**CPED STAFF REPORT**  
Prepared for the Zoning & Planning Committee

Z&P Agenda Item  
March 26, 2015  
BZZ-6992

*Property Location:* 1919-1921 10<sup>th</sup> Avenue South  
*Project Name:* Franklin Street Bakery Parking Lot  
*Prepared By:* [Janelle Widmeier](#), Senior City Planner, (612) 673-3156  
*Applicant:* Franklin Bakery, LLC  
*Project Contact:* Aubrie Eisenhart, Master Properties, LLC  
*Request:* To allow a temporary parking lot.  
*Required Applications:*

Site Plan for 1919 and 1921 10<sup>th</sup> Avenue South, Minneapolis, Minnesota 55404

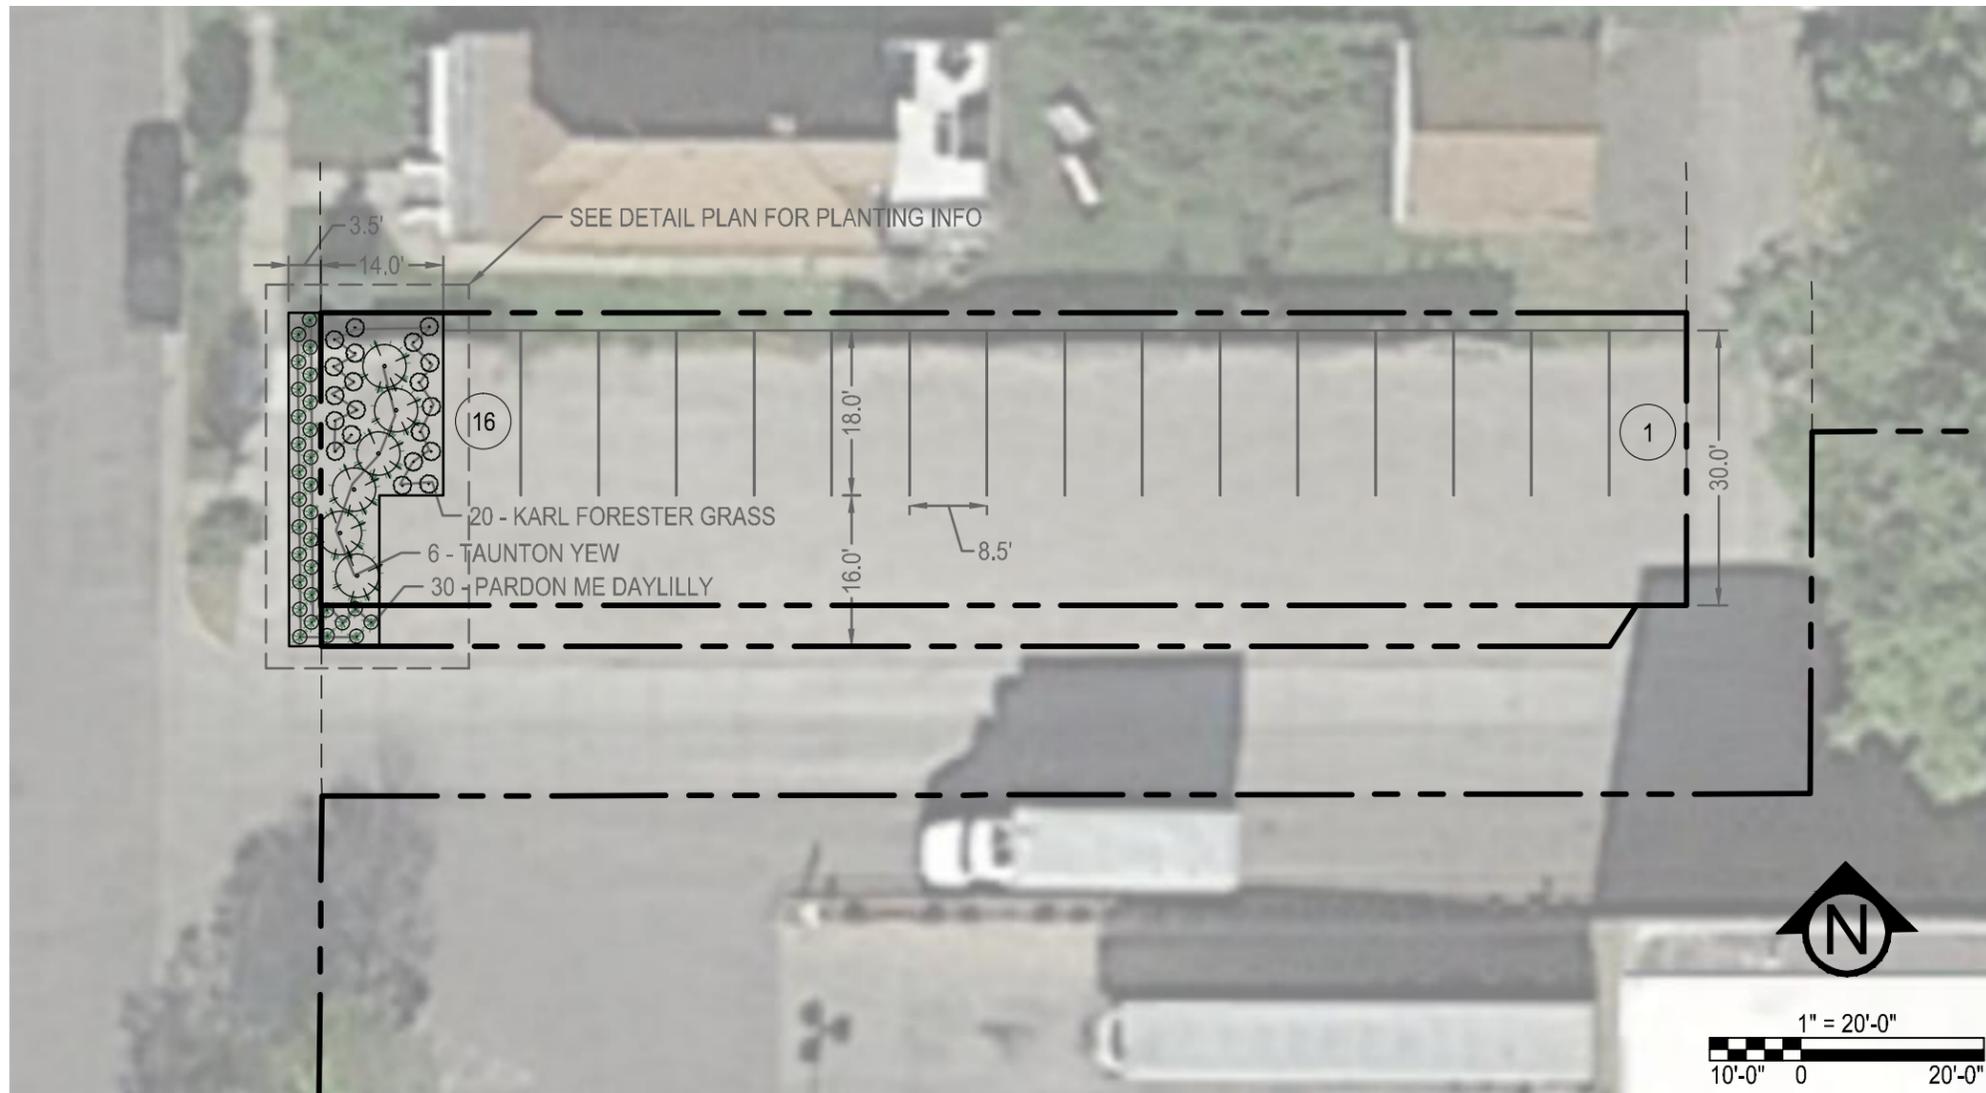
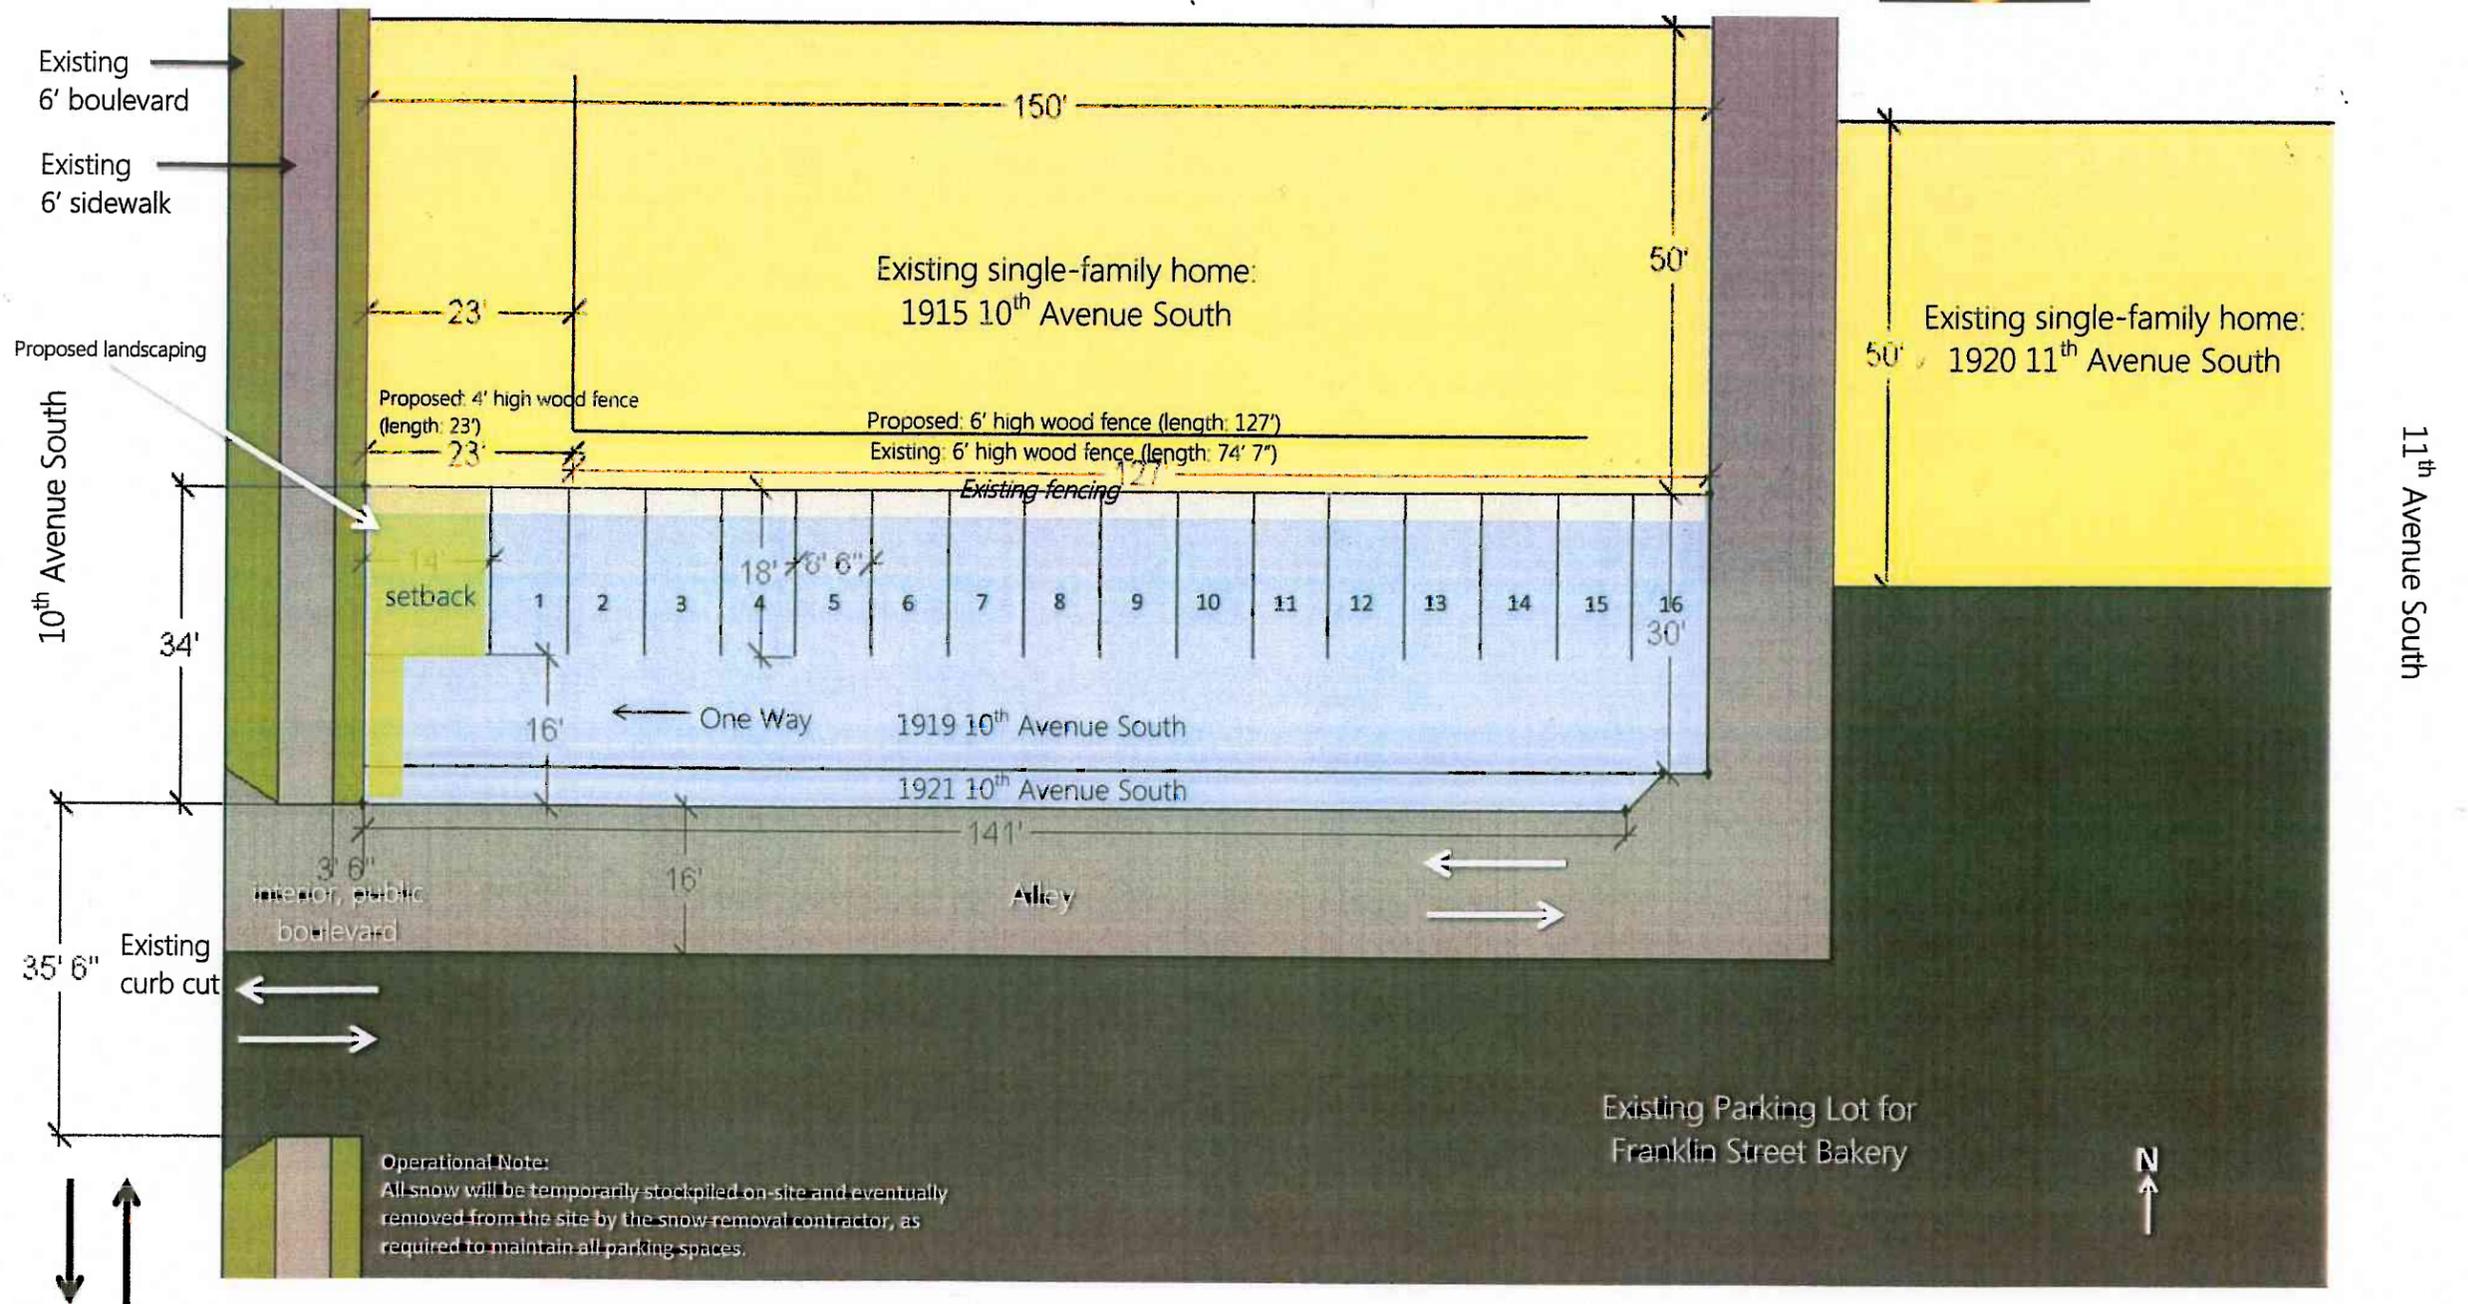
The parking lot is for employees of Franklin Street Bakery and is not expected to be detrimental to public health, safety, comfort or general welfare. A minimum 20-foot wide drive aisle is required for one-way traffic. With only a 16-foot wide drive aisle provided on-site, the potential for conflicts between the parking area and alley traffic increases because some maneuvering will occur in the alley. The alley is L-shaped, which should slow traffic. Loading and driveway space on the Franklin Street Bakery site also abutting the alley should allow sufficient room for vehicles to maneuver in the interim.

A two-family dwelling is located directly north of the subject property and the Franklin Street Bakery (and its on-site parking) is located directly south of the alley. The parking lot is not proposed in a manner that would comply with all applicable zoning code requirements, including but not limited to, surfacing, yards, drive aisle and maneuvering. Given that the parking lot proposal is temporary until future expansion plans can be implemented, it should have little effect on surrounding properties with the adoption of the staff recommendation. To ensure any adverse impacts are minimal, CPED staff is recommending that the duration of the interim use not exceed 2 years from the date of the Council action and that a minimum 23 foot deep landscaped yard (the established setback requirement) be provided adjacent to 10<sup>th</sup> Avenue.

The property and business to be served by the proposed parking lot is located on the Franklin Avenue commercial corridor. The applicant has indicated that the parking lot is necessary to provide needed parking for the business, which is a retail and light industrial use. The proposed parking facility would not be consistent with the policies noted in the comprehensive plan related to the design of surface parking lots. The parking lot is not proposed in a manner that would comply with all applicable zoning code requirements, including but not limited to, surfacing, yards, drive aisle and maneuvering. One purpose of an interim use permit is to temporarily allow uses that may not be consistent with adopted long-term plans and objectives for the area in question. The parking lot will have a fence along the north lot line to provide the required screening from the adjacent residence. The applicant is proposing to provide a 14 foot wide landscaped yard between parking space #1 and 10<sup>th</sup> Avenue and a 6 foot wide landscaped yard between the drive aisle and 10<sup>th</sup> Avenue. The established front yard setback of the dwelling to the north is 23 feet. Because all of the properties to the north of the parking lot are residential and to ensure that the existing street face is retained, staff is recommending that the City Council require a minimum 23 foot wide landscaped front yard. This condition of approval would eliminate parking space #1.

- **Maneuvering area and drive aisle width** (541.290 and 541.330): All maneuvering is required to occur on-site. The minimum width required for a one-way drive aisle is 20 feet. A 16-foot wide drive aisle is proposed. As a result, some maneuvering overlaps the adjacent public alley. The maneuvering is discussed further in finding #1 above.

- **Marking of spaces** (541.320): All parking spaces are required to be clearly marked. The parking surface is not conducive to markings.
  - **General landscaping** (530.160): Twenty percent of the site, or 1,016 square feet, is required to be landscaped with at least one tree and 10 shrubs. The proposed landscaped area would cover 348 square feet, or 6.8 percent of the site. No trees are proposed. Six shrubs are proposed. With the adoption of the staff recommendation to require a 23 foot wide landscaped front yard, the on-site landscaped area would increase to 782 square feet.

- **Required front yard and landscaping between the parking area and the street** (530.170, 546.160, and 550.160): In the R2B district, the minimum front yard requirement is 20 feet or the established setback of an adjacent residential property, whichever is greater. The adjacent residence to the north is setback 23 feet; therefore, the parking is subject to a 23 foot required front yard setback. The part of the parking area zoned II is subject to a 20 foot wide front yard requirement. In the required front yard, at least 2 trees and a screen that is 3 feet tall and at least 60 percent opaque is also required. The proposed landscaped front yard is 6 to 14 feet wide. Six shrubs are proposed to provide the required screening. Staff is not recommending that these requirements be waived in the interim. A future expansion would likely be subject to a front yard requirement and the landscaping could be retained or relocated. It would also ensure that the existing residential street face would be maintained. As can be seen in the attached photos, vehicles have driven across the area within the required front yard. Turf will need to be reestablished in the boulevard between the sidewalk and curb. To prevent vehicles from driving over or parking on the required landscaped area, staff is recommending that a fence or other barrier is provided.

- **Interior side and rear yards and landscaping between the parking area and the adjacent residences** (530.170 and 546.400): Per the R2B district requirements, a minimum 5 foot wide interior side yard and rear yard are required adjacent to the north and east lot lines respectively. Per the site plan review standards, landscaped yards at least 7 feet in width are required adjacent to these lot lines. No landscaped yards are proposed in these areas. These areas of the site would be altered as part of any future expansion making substantial investment impractical. The fence along the north lot line will provide the required screening. The residence to the east is separated from the site by the public alley.

- **Other landscaping requirements** (530.170): Each parking space is required to be located within 50 feet of an on-site tree. No spaces would comply with this requirement. Staff is recommending that required landscaping, including trees, be provided in the front yard. Requiring trees elsewhere on the site would require more substantial investment, which is impractical for this interim use.

- **Lot width** (Table 546-9): The minimum lot width required is 40 feet. The site is 34 feet wide. The proposed width is not sufficient for a permanent parking facility because all maneuvering cannot occur on-site and a landscape buffer cannot be provided for adjacent residential uses.

- **Impervious surface coverage (546.150):** The existing surfacing is considered impervious by definition of the zoning code. In the R2B district, not more than 60 percent of the site can be covered by impervious surfaces. 93.2 percent of the site is proposed to be covered by impervious surfaces. Staff is recommending that additional landscaping be provided to reduce that number to 84.6 percent.

3. A front yard at least 23 feet in width shall be provided between the parking area and 10<sup>th</sup> Avenue in full conformance with the landscaping and screening requirements of section 530.170 of the zoning code.

4. A barrier, such as a fence or boulders, shall be provided between the parking area and the landscaping to clearly define the parking area and prevent vehicles from driving on or parking in the required front yard.

5. Turf shall be reestablished in between the public sidewalk and street curb.
6. As needed for maintenance, the parking lot surfacing shall be recompacted.
